REMARKS

VERSION WITH MARKINGS TO SHOW CHANGES MADE

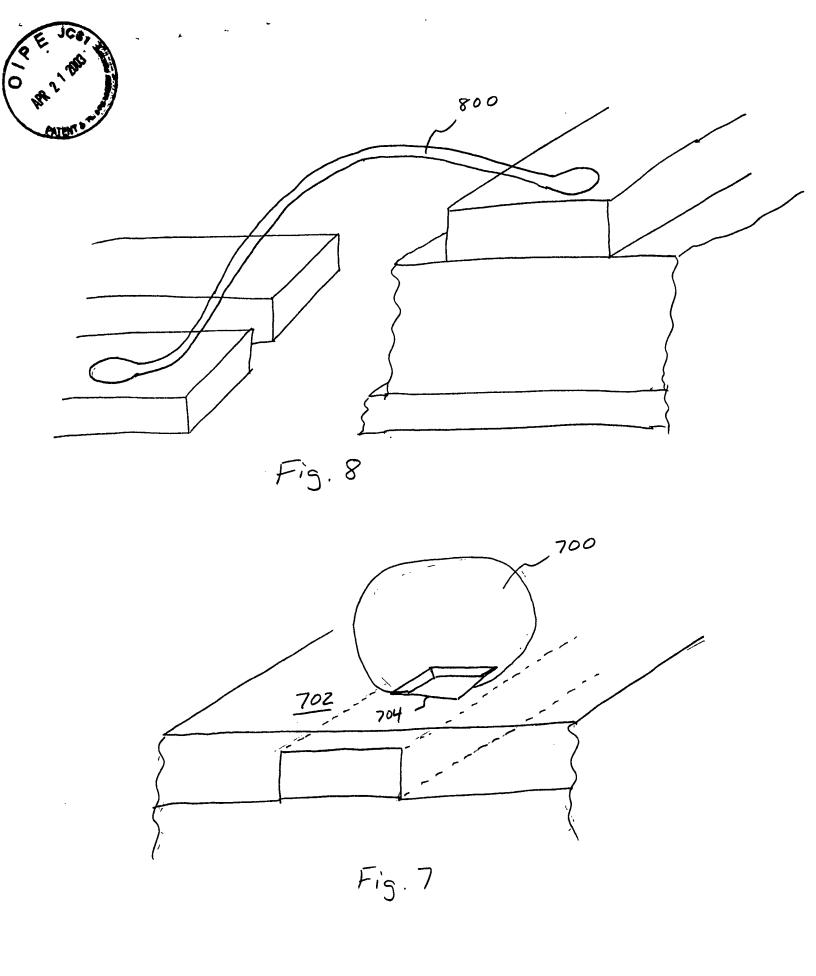
The drawings were objected to for not showing every feature of the claimed invention. New Figures 7 and 8 are proposed herein in response to the objection.

- FIG. 6 is a schematic diagram of individualized power distribution lines deposited over an active IC for lowering electrical parasitics.
- FIG. 7 is a simplified perspective and cross sectional view of a power distribution line over an integrated circuit (IC) fabricated in a semiconductor chip with a solder ball mounted to the distribution line through an opening in a solder mask layer.

- FIG. 8 is a simplified perspective and cross sectional view of a power distribution line over an integrated circuit (IC) fabricated in a semiconductor chip with a ribbon connecting the distribution line to a leadframe segment.

If outermost layer 165 is selected so that it is solderable, a solder ball (700 in Figure 7) can be attached to it by standard reflow techniques. However, it was described in the abovecited U.S. Patent Application # 09/611,623 that it is often advisable to employ an additional solder mask 702 or polyimide layer [(not

shown in Figure 1)] with an opening <u>704</u> for each solder ball. This technique keeps the flip-chip bump in a defined area and shape during bump formation and subsequent attachment to an external package or board.

Outermost metal layer 165 is equally well suited for wedge bonding, involving ribbons (800 in Figure 8).
